From: [Kirk Chambers](#)
To: [Lockett, Jay](#)
Subject: Fwd: Planning Commission 2221 BRADFORD DR 40218
Date: Monday, July 17, 2023 12:26:02 PM
Attachments: [Screen Shot 2023-07-15 at 5:20:14 PM.png](#)
[Screen Shot 2023-07-15 at 5:21:02 PM.png](#)
[Screen Shot 2023-07-15 at 7:05:18 PM.png](#)

2221 Bradford Drive

Looking over the proposed plan the following are my comments.

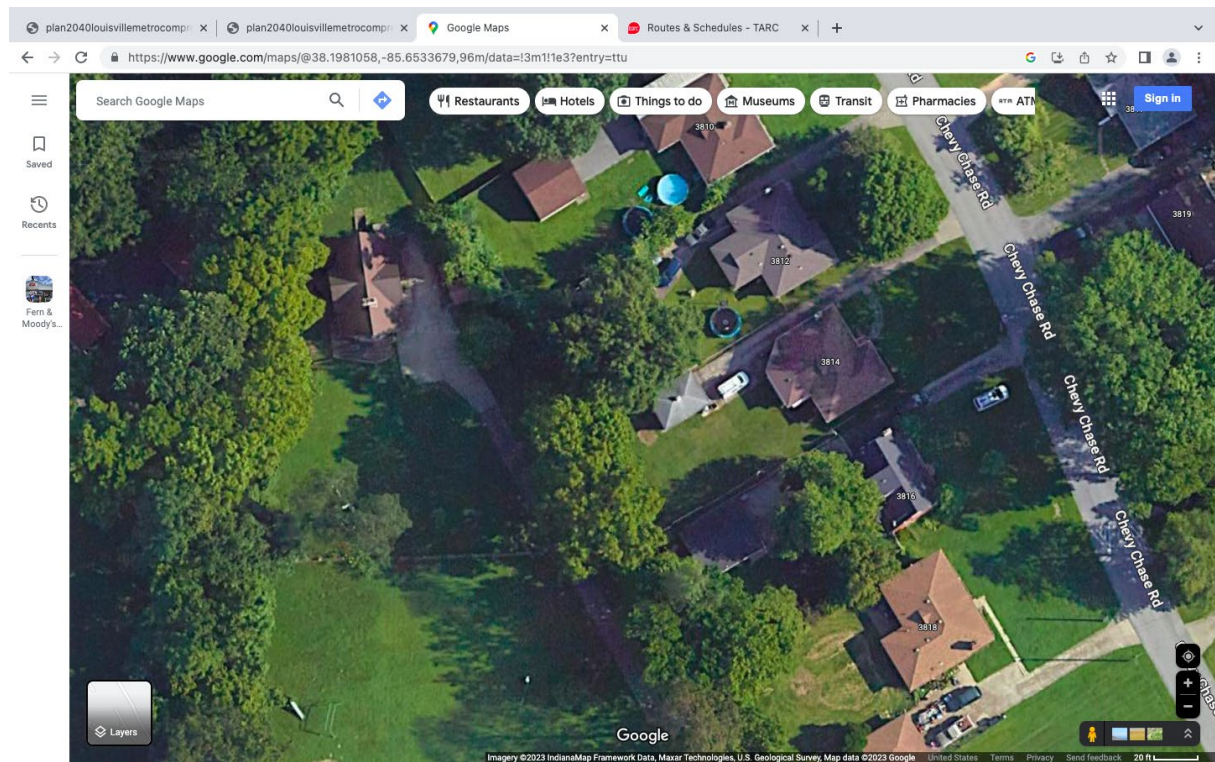
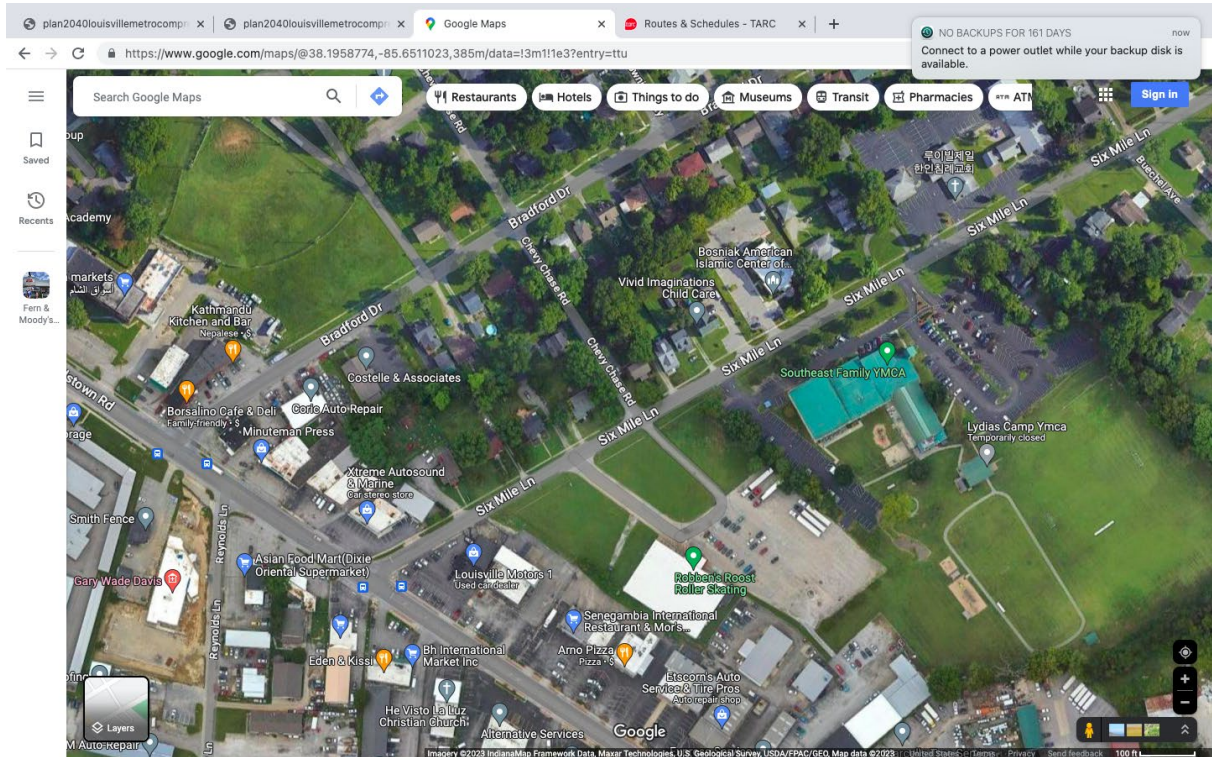
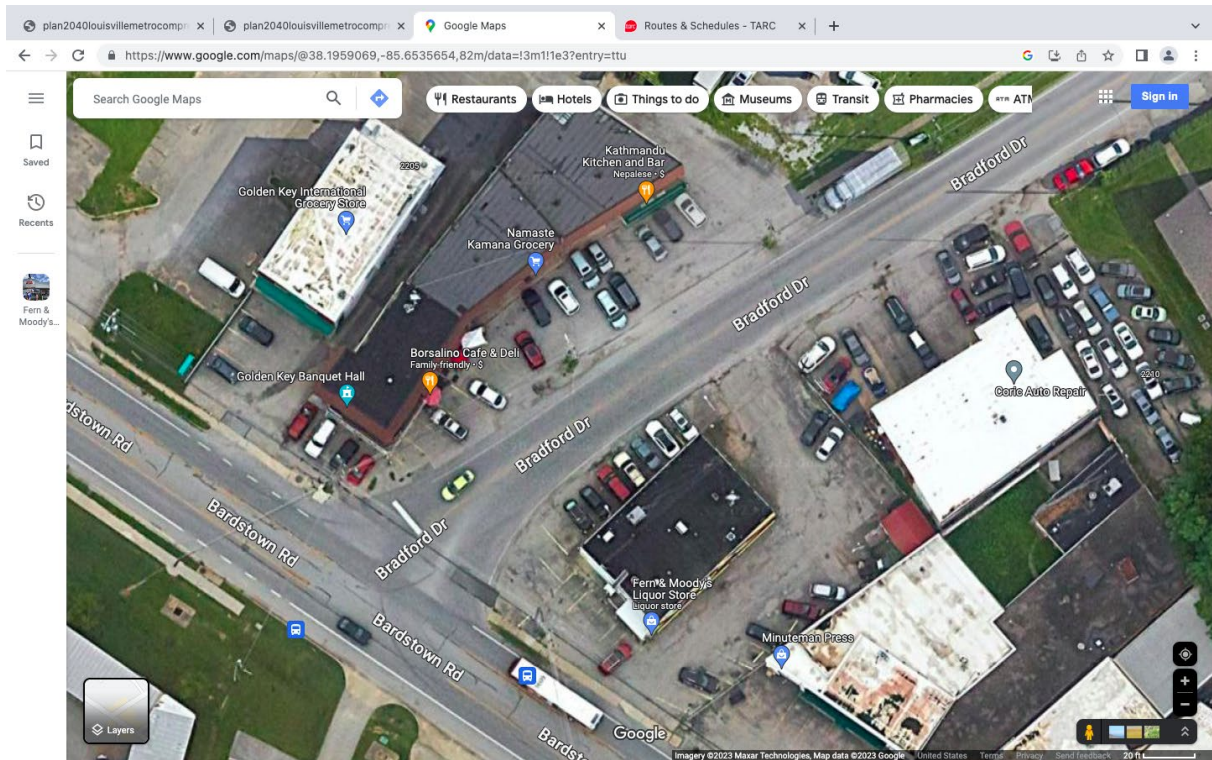
1. 20' setback from property line is inconsistent with neighboring size of yards. Houses are on 100' setback from property line.
2. back door to buildings with no property features to utilize. No natural barrier to expand living space to fence

4. Open space design places buildings up against residential side and away from commercial side.
5. flow of walkers from property to local YMCA will add additional walkers to streets that lack side walks

6. route out of property to bus routes is through business parking lots that would not be up to code for anyone.
7. Person currently staying in the house indicated they were staying in the house once the property is completed. If the house is staying residential, it needs to be counted in the occupancy numbers.

The proposed design takes the R6 requirements to the limit. 5 of the 6 building contain 16 units. If the 6th building contained the same number of units, it would be over the R6 limit, thus it was reduced to 14 units. The details of the property are pushed to the very limit at the point they interact with the existing housing. This density does not follow the Plan2040
